Peak-to-peak output measurement results and proposal

Comments #82, #93, #94

Adee Ran, Cisco

IEEE P802.3dj Task Force interim meeting, Hamburg

Figure 93-6—Transmitter output voltage definitions

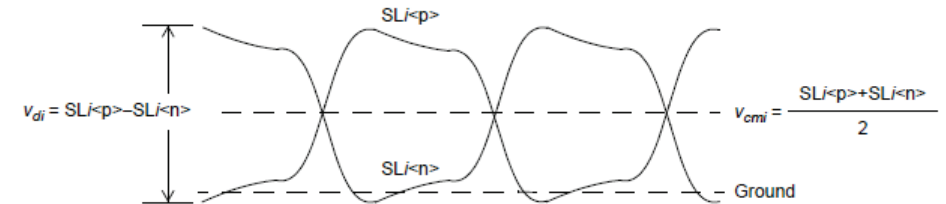
Neither this diagram nor the text around it define the peak-to-peak voltage. The diagram does not resemble a PAM4 signal after IL of >30 dB.

Contrary to the footnote, 93.8.1.3 does not describe a measurement method. The only relevant information is the test pattern, which is overridden by the footnote.
